FEDERAL COMMUNICATIONS COMMISSION

In re: NEW, Del Rio, TX
BNPFT-20030827AKH
Facility ID # 141067

This refers to: (1) the above-captioned application for a new FM translator in Del Rio, Texas.

THE FOLLOWING IS A LIST OF THE DATA WHICH APPEARS ON THE ABOVE MAP

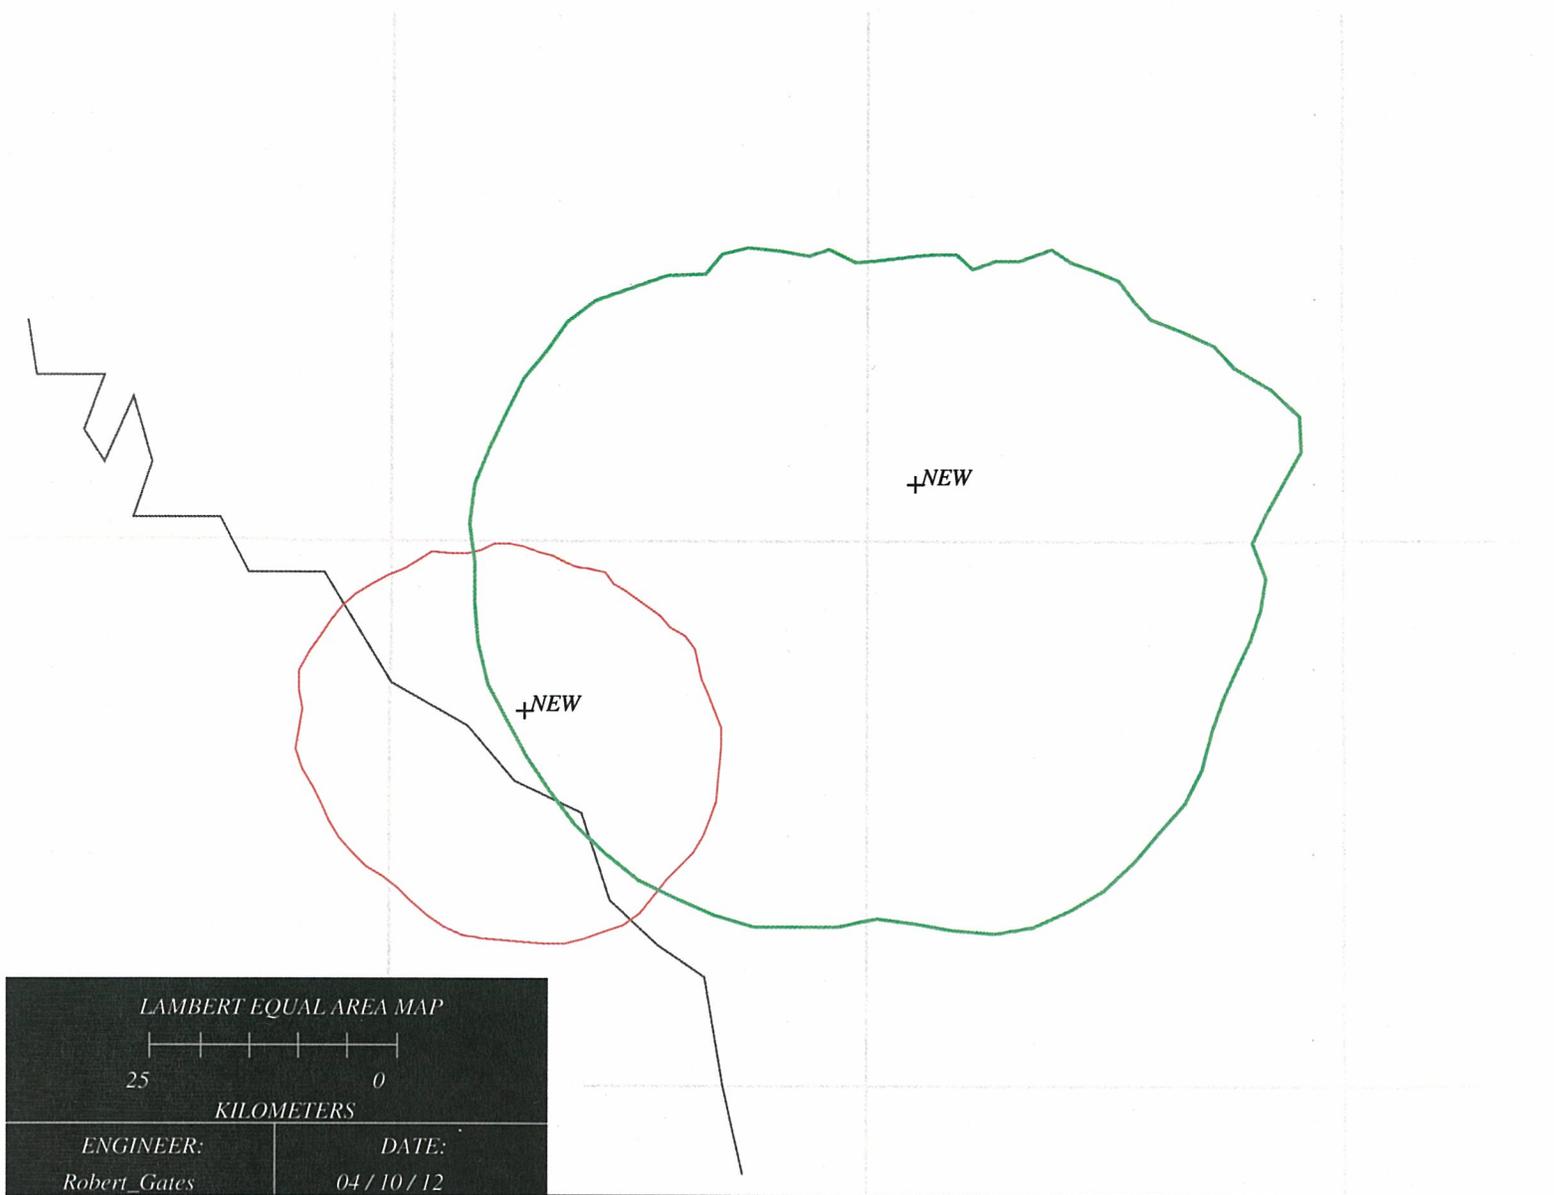
An engineering study has revealed the application violates 47 C.F.R. § 74.1204(a) with respect to KVDR(FM) (BNPH-20091019AFF) in Brackettville, Texas. Section 74.1204(a) states that an application for a FM translator station will not be accepted if the proposed operation would involve prohibited overlap of predicted field strength contours with any other authorized station. The proposed 40 dBu interference contour overlaps with the 60 dBu protected contour of KVDR(FM). This violation was not addressed.

In light of the above, the application BNPFT-20030827AKH filed by World Radio Network, Inc. is unacceptable for filing pursuant to 47 C.F.R. § 73.3566(a) and IS HEREBY DISMISSED. This action is taken pursuant to 47 C.F.R. § 0.283.
